**SJCOE Bid No. 2022/23-006-014-014011**  
**Henry + Associates Project No. 22-34-024**

**ADDENDUM NO. 02**  
**New Head Start Portable-SJCOE at BFA**  
San Joaquin County Office of Education  
Stockton, California

**RFI No.003**

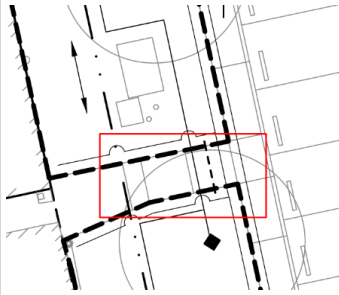
On sheet L4.1, the legend of sleeve indicates that " provide (2) 4" schedule 40 sleeves in location shown, and at all lateral line pavement crossings".  
 As image below, there are 1 Mainline and 3 Lateral lines under paving. So, does it mean we have total (2) 4" sleeve for Mainline and (6) 4" sleeve for Lateral line?  
 Please confirm if we understand correctly. If not, please explain the sleeve legend for us.

Provide sleeves for all piping under pavement, minimum 2x pipe size. Provide sleeve for wires, size to allow a maximum of 40% fill. Provide (2) additional 4" sleeves at locations shown on drawings.
